DRB Application No.: 03-00302 (SBP)	Project # 1002507
Project Name: ALAMEDA BUS. PK LOT 43	EPC Application No.:
Agent: Sanders & Associates Architects	Phone No.: 842-8413

DEVELOPMENT REVIEW BOARD TRANSPORTATION DEVELOPMENT Standard Comment Sheet

**CITY OF ALBUQUERQUE
PLANNING DEPARTMENT
Development Review Board
3/12/03 Comments**

Subject: Alameda Business Park, Lot 43/SBP

1 NORTH ELEVATION
SCALE: 1/8" = 1'-0"

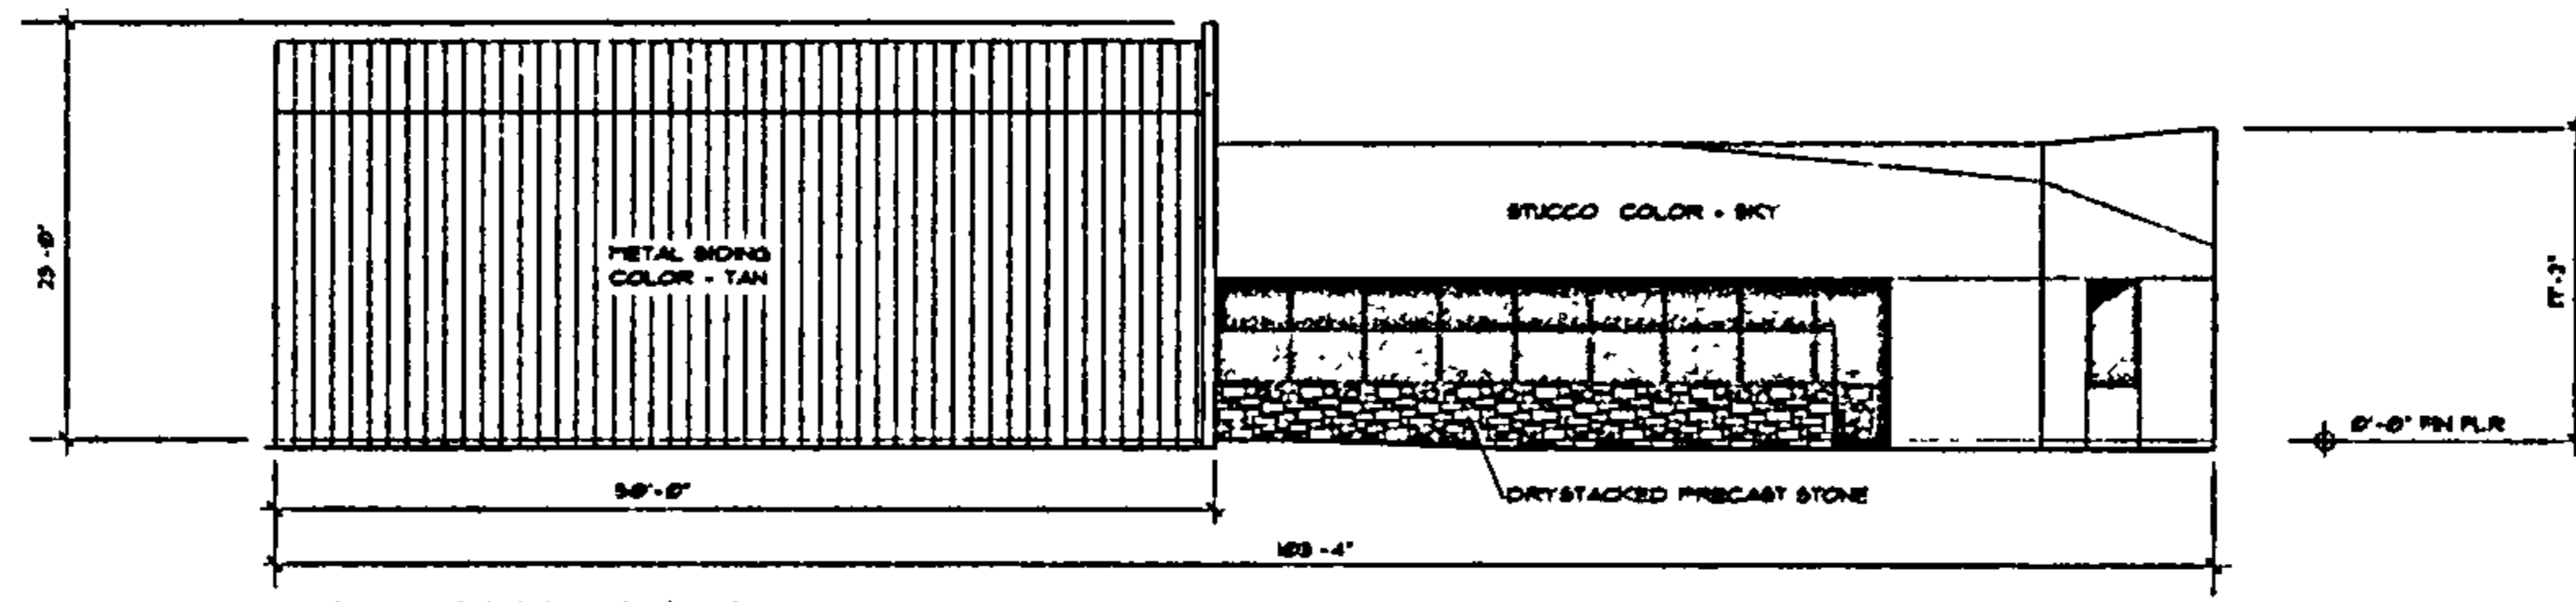
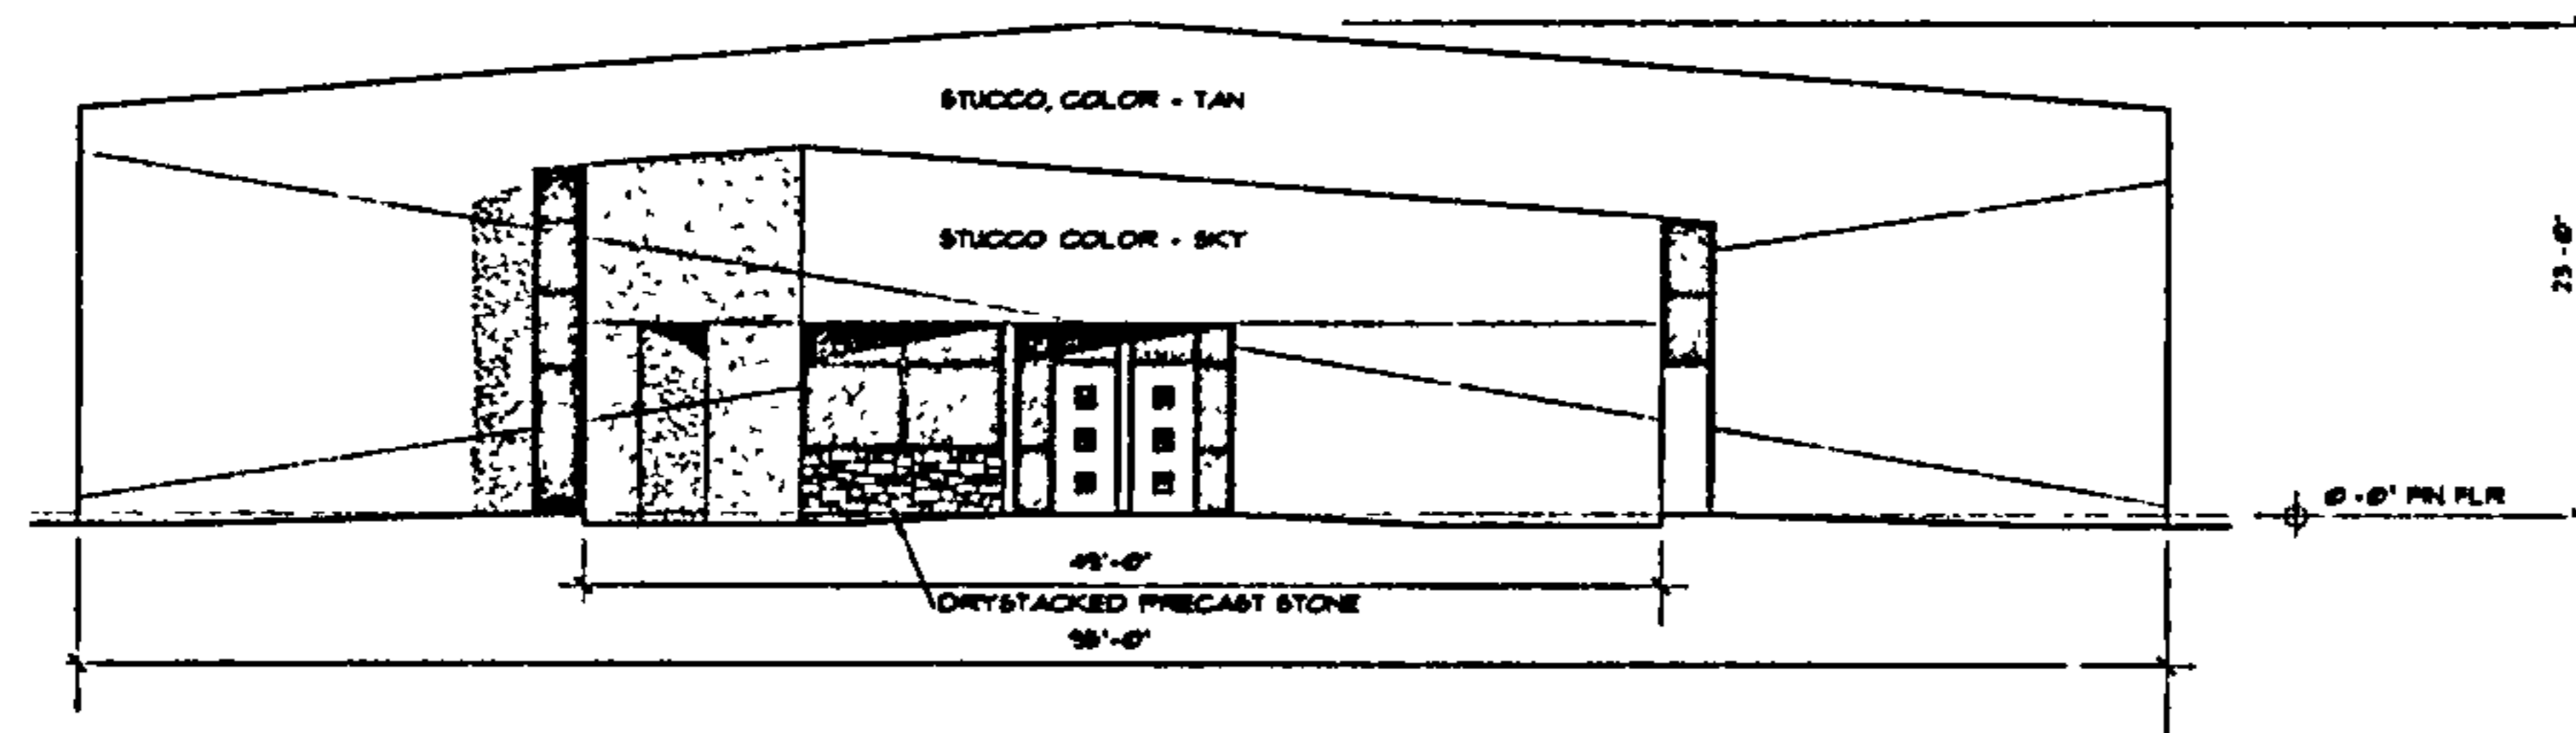
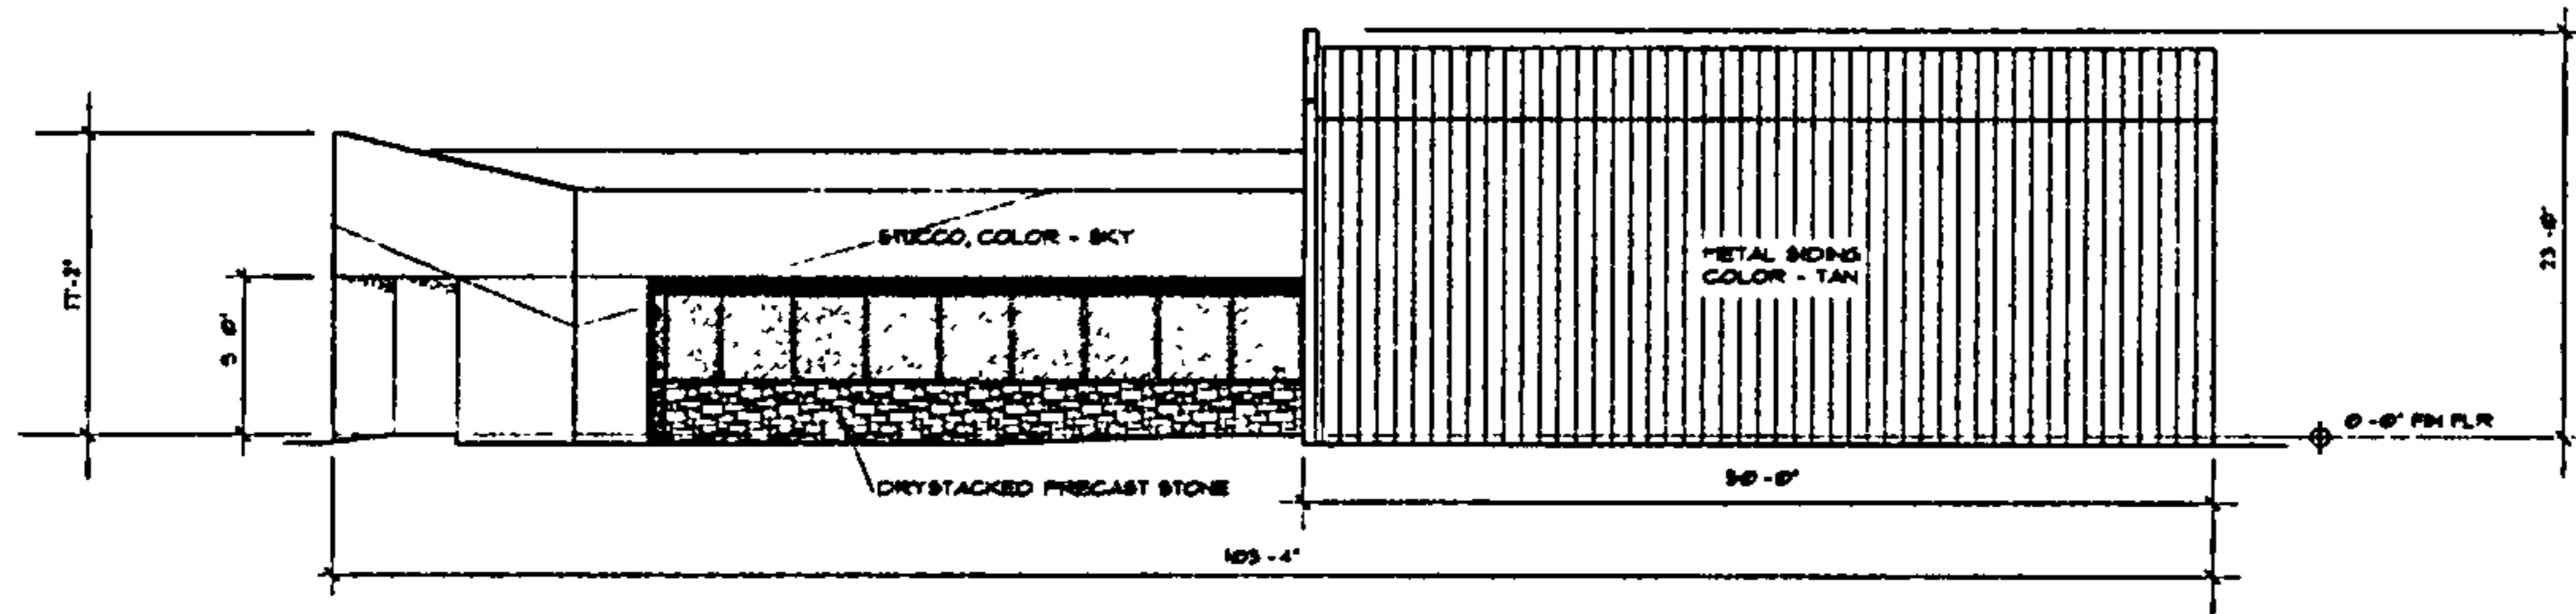
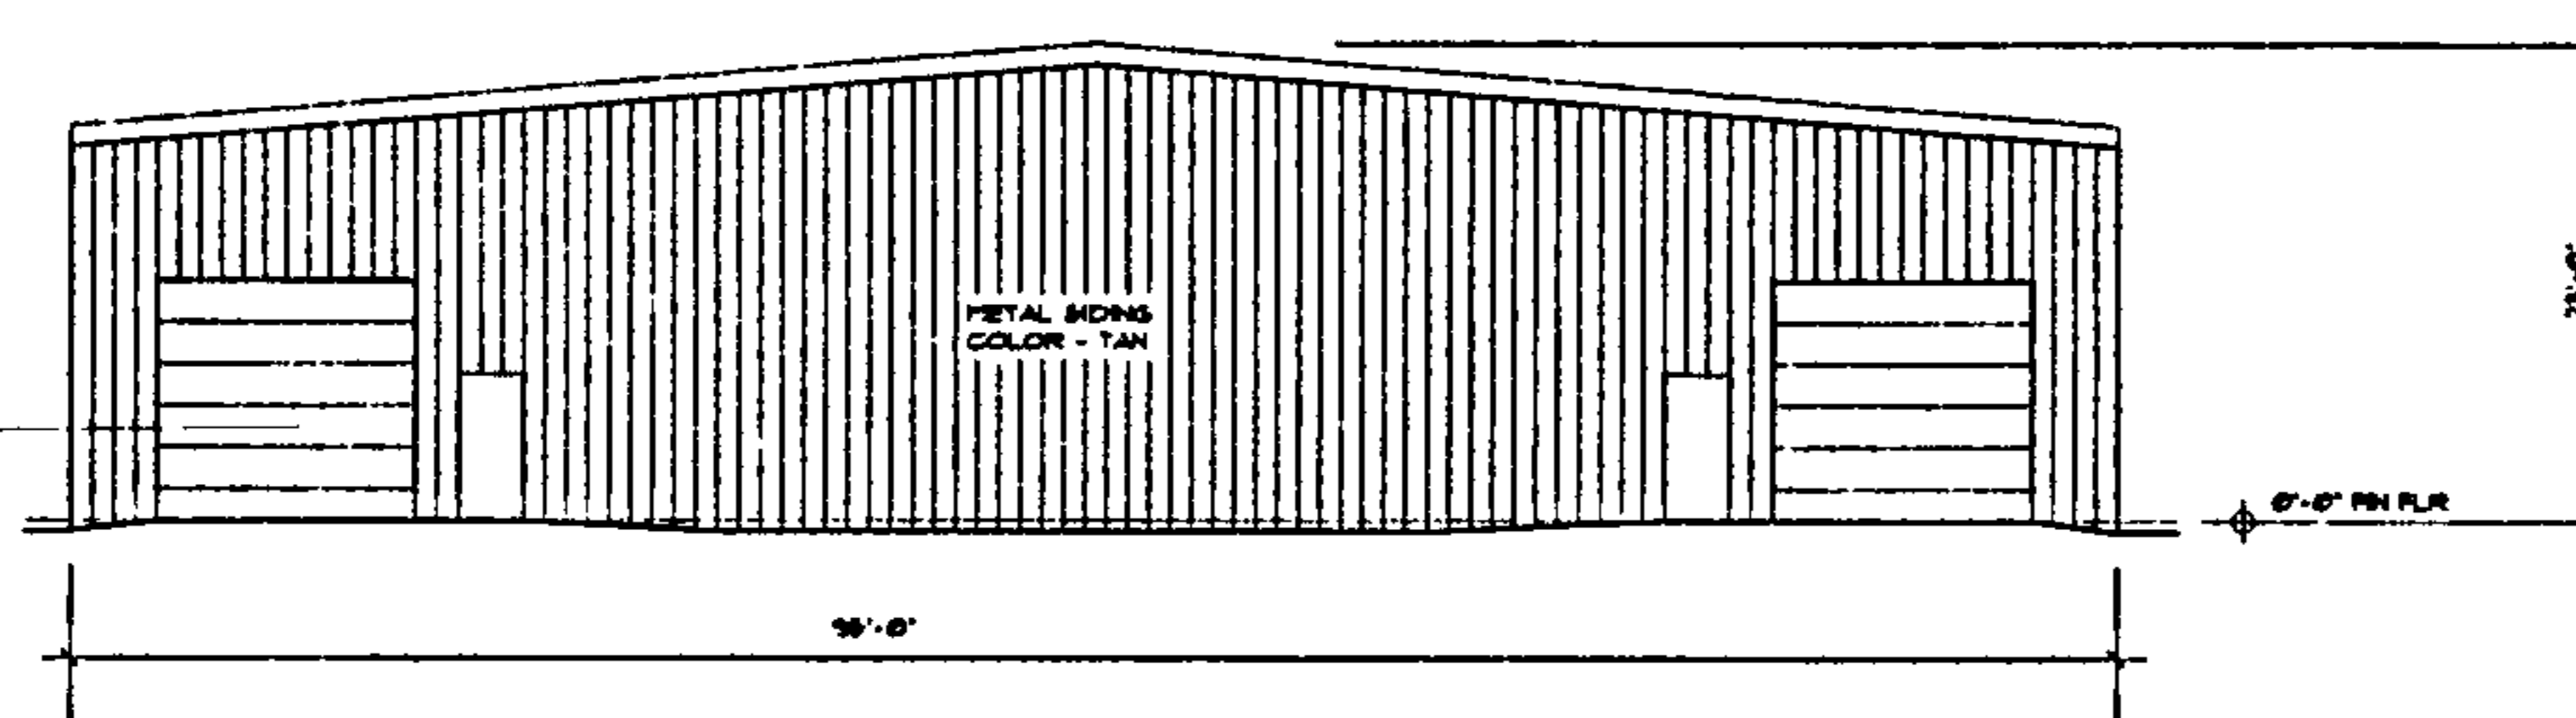
Materials and colors for the pitched roofs are to appear on the elevations page per the Master Plan.

Signs are not shown on the elevations page or the site plan. Signs should be shown and conform to the Master Plan requirements.

Materials and colors for the pitched roofs are to appear on the elevations page per the Master Plan.
